Intel Atom[®] Processor E3800

Specification Update

March 2021

Table 61. S4/S5 to S0 (Power Up) Sequence of the Intel Atom® Processor E3800 Product Family Datasheet, Doc #538136.

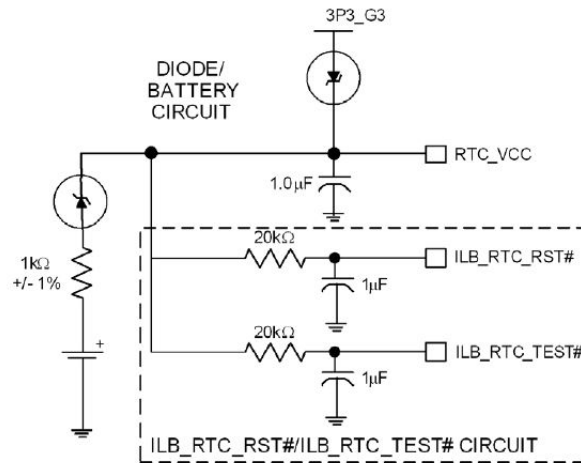
4. S4/S5 to S0 (Power Up) Sequence Specification Change

Note 5 from Table 61. S4/S5 to S0 (Power Up) Sequence of the *Intel Atom® Processor E3800 Product Family Datasheet*, Doc #538136, which specifies an alternate power-up sequence for the V1P0A & V1P8A rails, will be modified. The modified note will state:

These timings are allowed to have an error of up to 5%. When no max timing is specified, the actual timing should be as close to the min timing as possible under normal operating conditions (typically within one additional unit of time), but no max timing is guaranteed.
